# Guide to Traffic Engineering Practice Part 7 - Traffic Signals

## ERRATA LIST

Prepared by R. Akçelik  
Akcelik & Associates

11 February 2006

**Figure:** 5.6 (b)

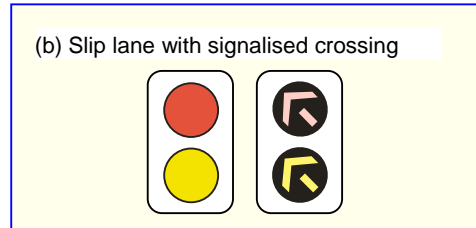
**Error:** Second signal face should show red arrow rather than red circle.

**Figure:** 7.7

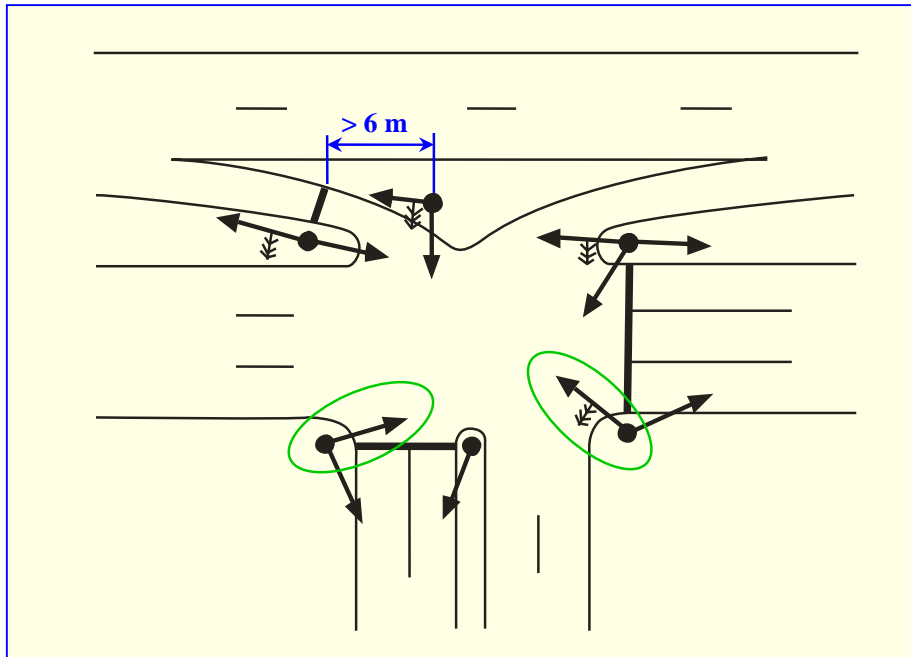
**Note:** A Tertiary signal face added for East approach, and a Secondary signal face added for West approach (right turn).

**Figure:** 8.3 (a)

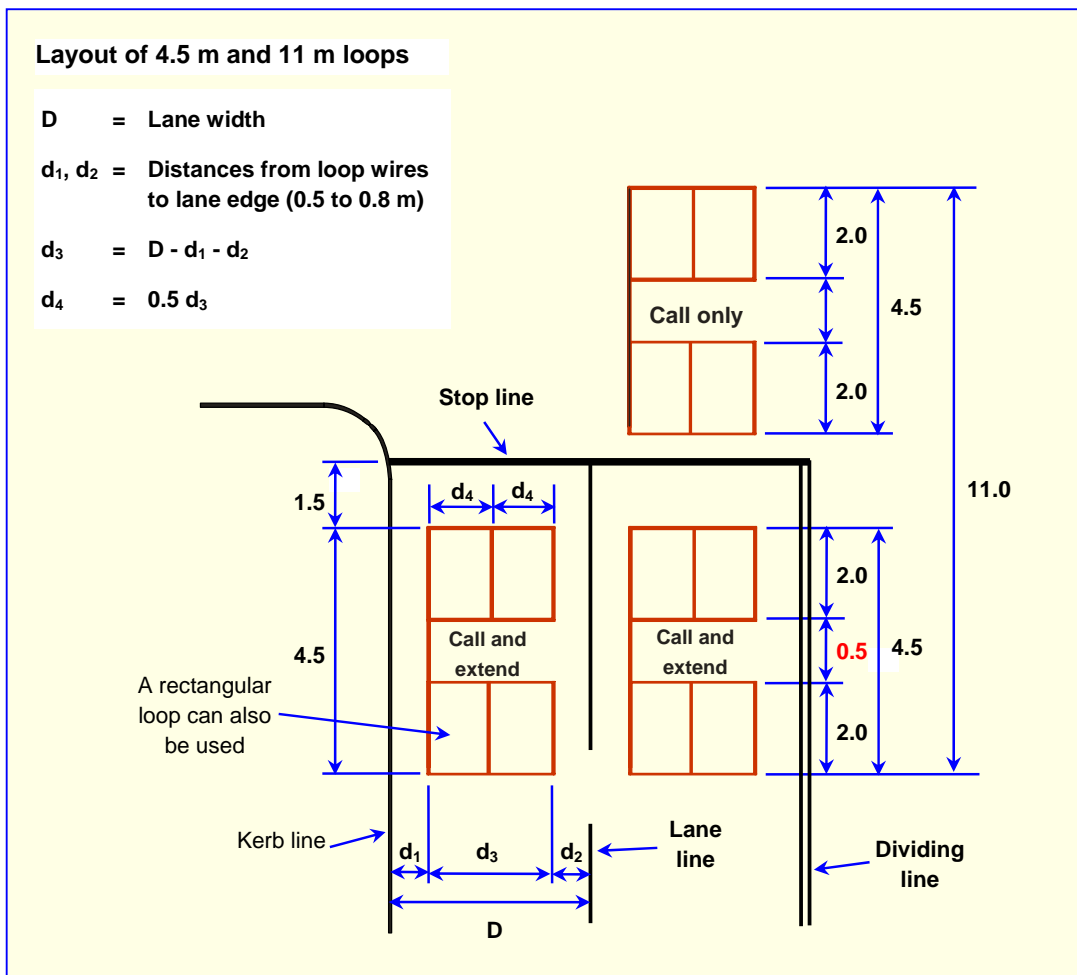
**Error:** Gap between the two sections of the loop in the right-hand lane should be 0.5 m (not 2.0 m).

**Figure:** 9.2

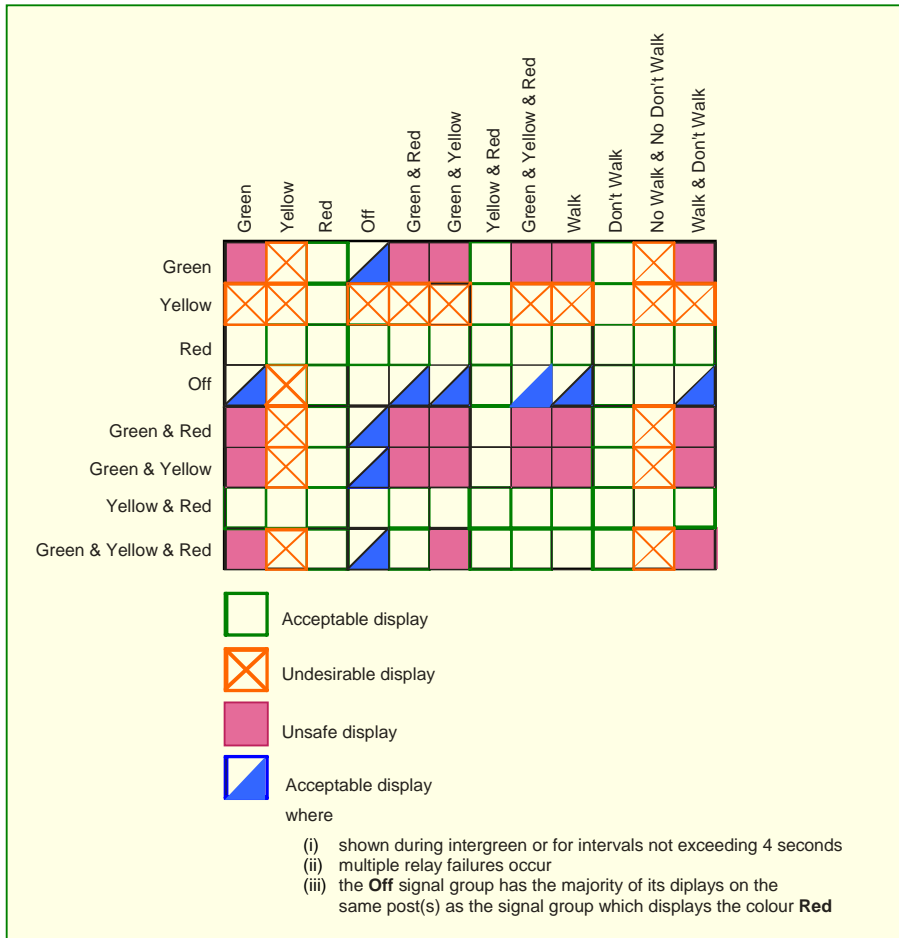
**Error:** Acceptable display and undesirable display symbols are wrong. Correct figure is given below.

**Figure:** D.7

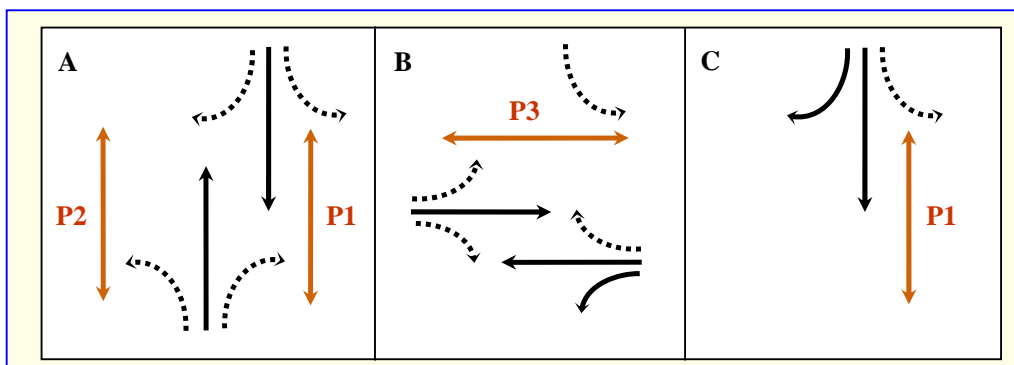
**Note:** Left turn movement in Phase C should be shown as a broken line due to pedestrian conflict.
